August 9, 2010

RE: SUMMIT COUNTY  
SUMMIT LAKE BASIN  
CITY OF AKRON  
DR THOMAS MC EBRIGHT  
COMMUNITY LEARNING CENTER

**NOTICE OF DEFICIENCY**

Figure 1. The sediment trap has been eliminated and final grading is taking place.

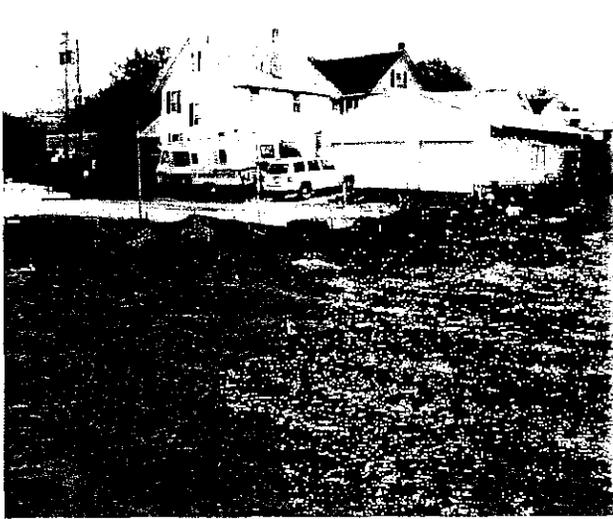
- The sediment trap has been eliminated (Figure 1). Issues with the sediment trap were documented during the first inspection and discussed with the contractor and engineer. The underground detention system is now being used. The underground detention system must be maintained and cleaned out as necessary.

Figure 3. Improper inlet protection was observed.

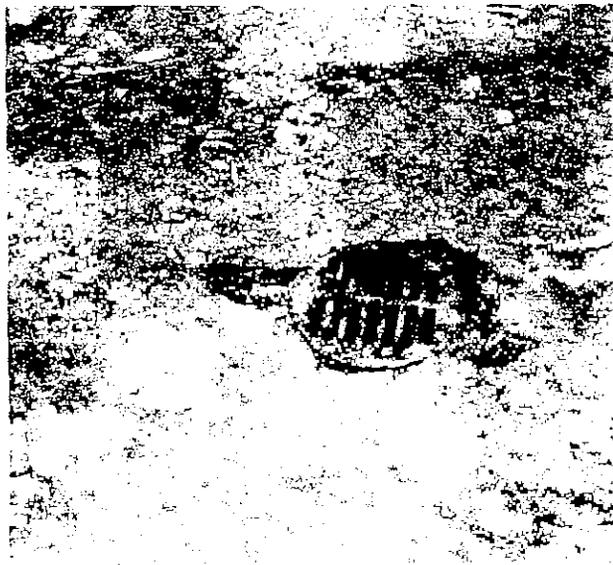
- Improper inlet protection has been installed in the site's storm sewer inlets (Figures 2 and 3). A conversation between the site's engineer, Paul Schmoll, and myself allowed for the use of filter fabric wrapped around the grates with stone being placed on top of the grates. It was observed during the inspection that this method is not being utilized on all storm sewer inlets. **Install an approved method of inlet protection on all of the site's storm sewer inlets immediately.**
